12555  
6 December 2012

**MP10\_0127 AND MP10\_0128 - MODIFICATION APPLICATION NO. 1  
ROPES CREEK EMPLOYMENT PRECINCT**

On behalf of Jacfin we hereby submit an application pursuant to section 75W of the *Environmental Planning and Assessment Act, 1979* (EP&A Act) to modify Concept Plan Approval MP10\_0127 and Project Approval MP10\_0128 relating to the development of an industrial estate for light industry, warehouses and distribution centres at Ropes Creek.

Figure 1 – Revised Concept Plan showing Transgrid Acquired Land

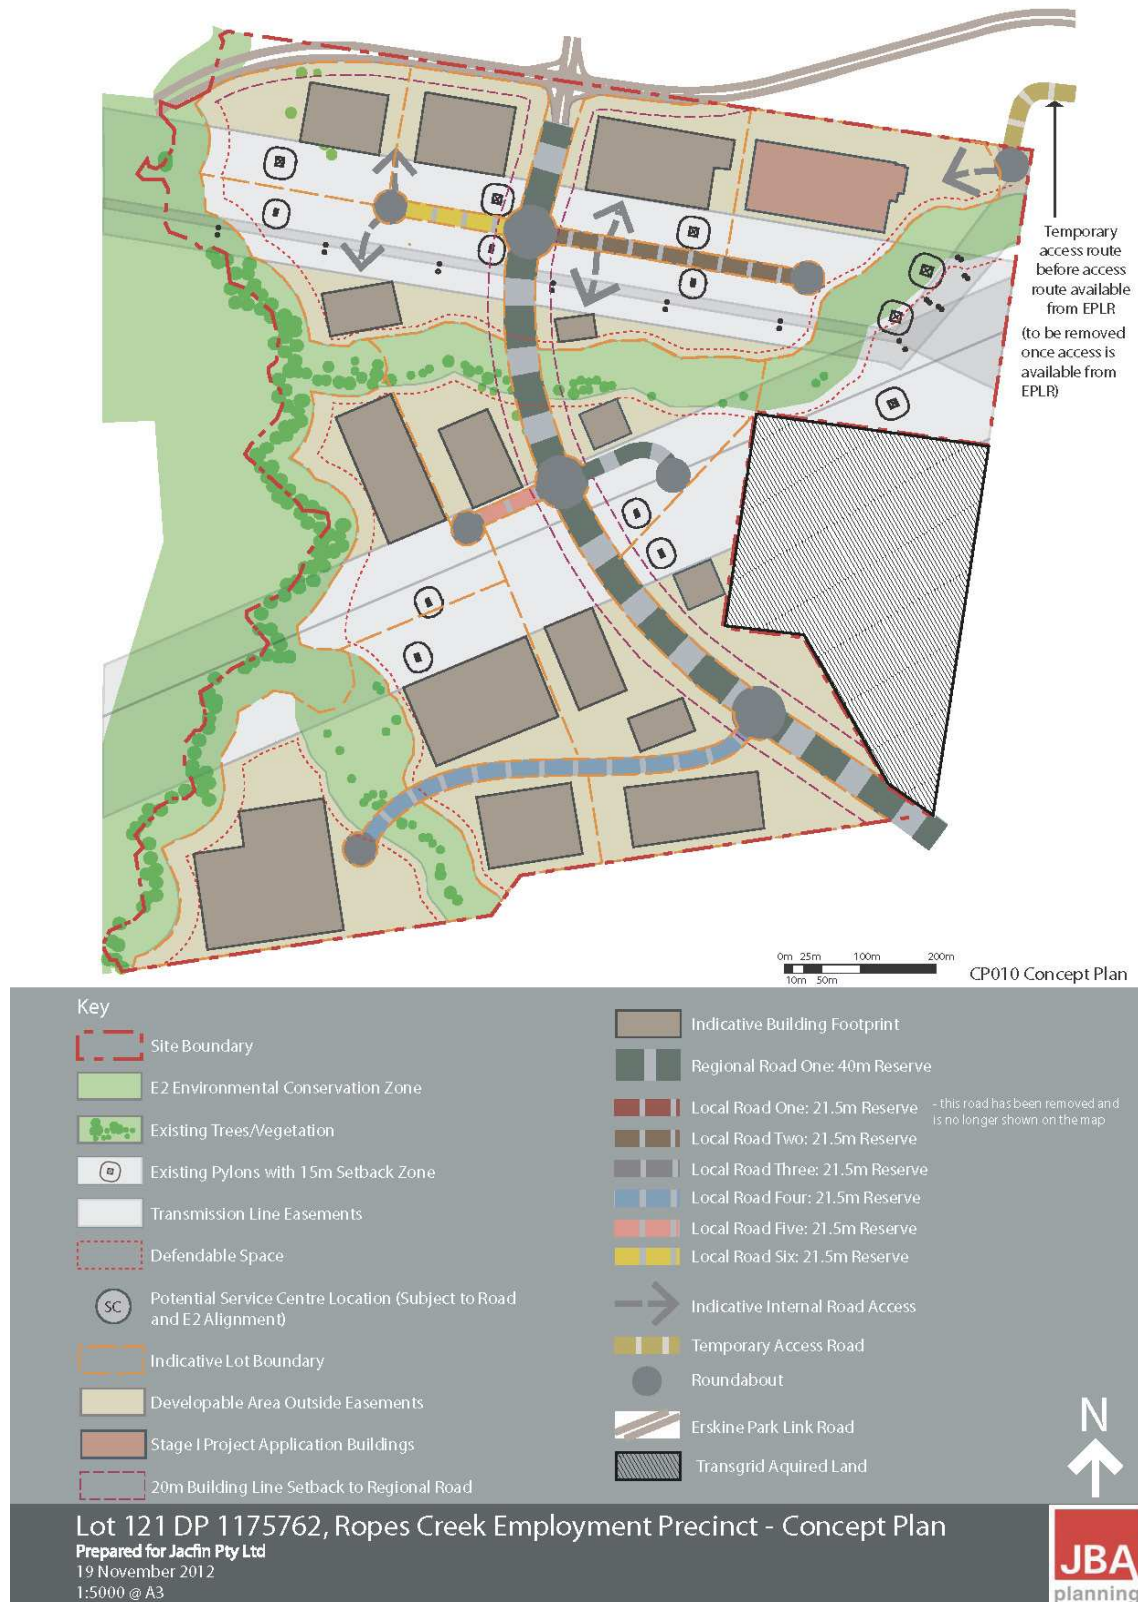
The following modifications are proposed to the approved development. A revised concept plan showing the location of the land that has been acquired by Transgrid and the changes to the proposed development is provided in **Figure 1**, and additional plans are provided in **Attachment B**.

- Removal of Lot 120 DP 1175762 from the land to which the Concept Plan relates.
- Removal of Local Road 1 as it is no longer required for access to the southeast part of the site.
- Truncation of Local Road 2 west of the E2 zone as it is no longer required to connect to Local Road 1.
- Extension of Local Road 3 to provide access to the residual land in the south-east part of the site, being land west of the Transgrid acquired land and north of Regional Road 1.

## Lot 121 DP 1175762, Ropes Creek Employment Precinct - Concept Plan

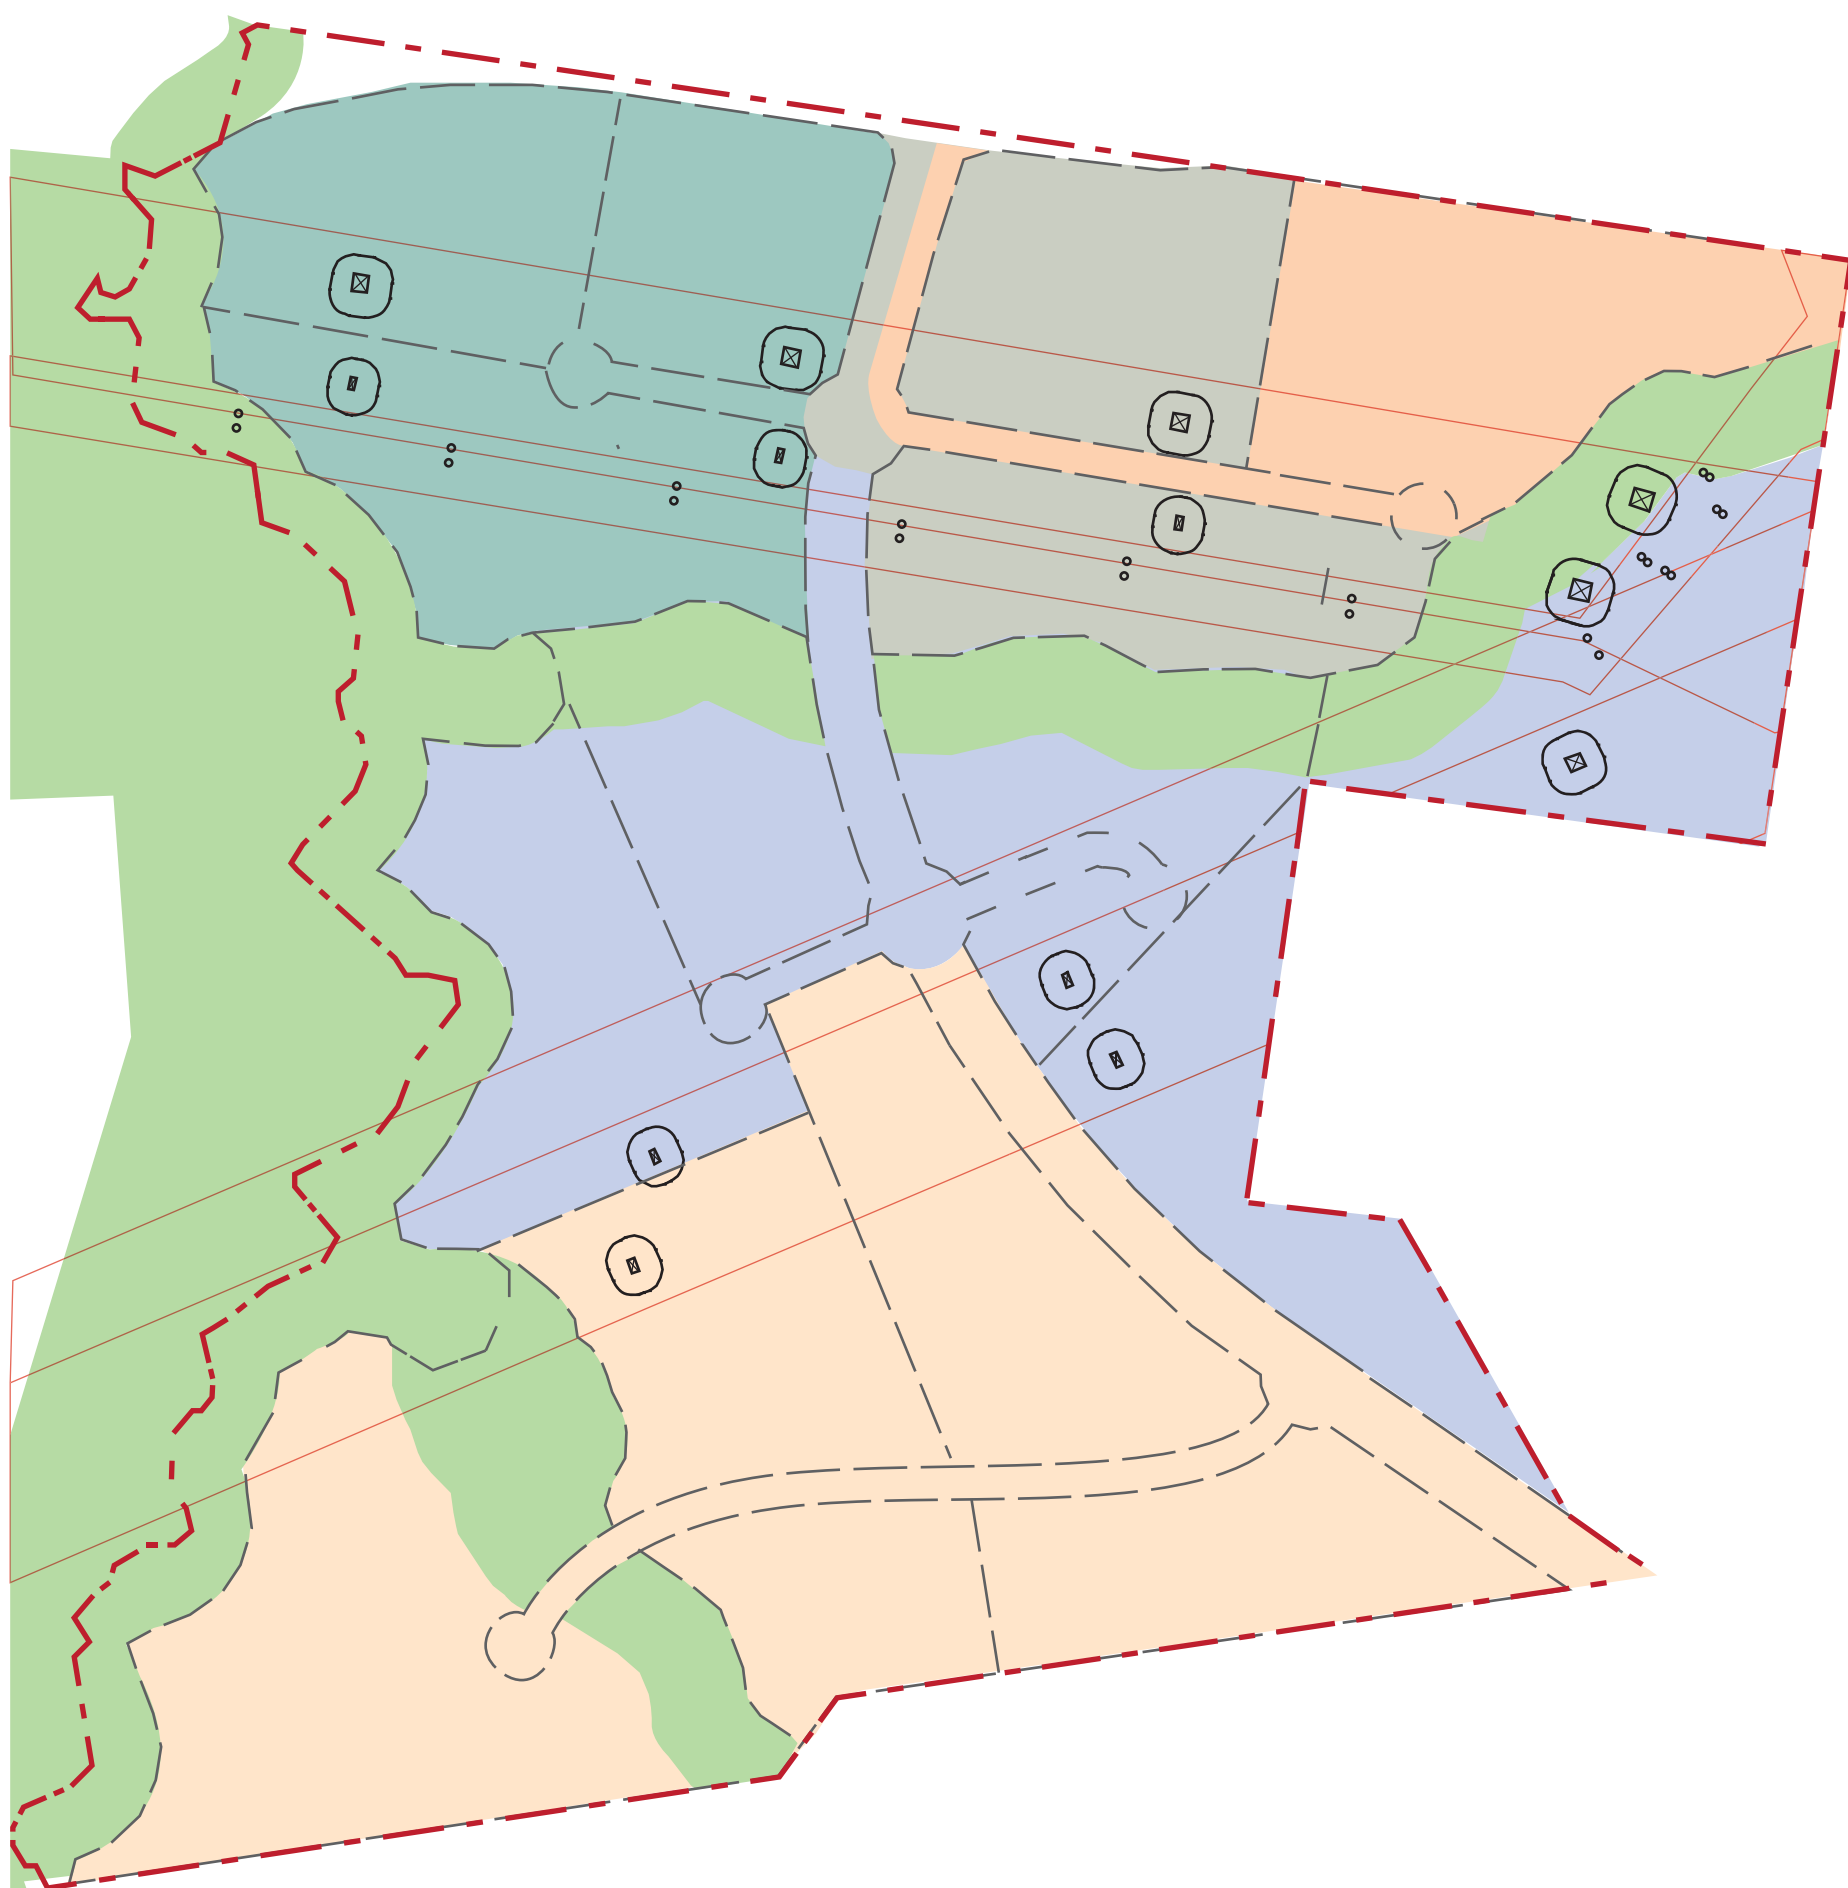
- Replace Appendix 1 with revised Concept Plan (CP010) dated 31 October 2012 (provided in **Attachment B**).
- Replace Appendix 2 with the revised Staging Plan (CP011) dated 31 October 2012 (provided in **Attachment B**).

Local Road One: 21.5m Reserve - this road has been removed and is no longer shown on the map
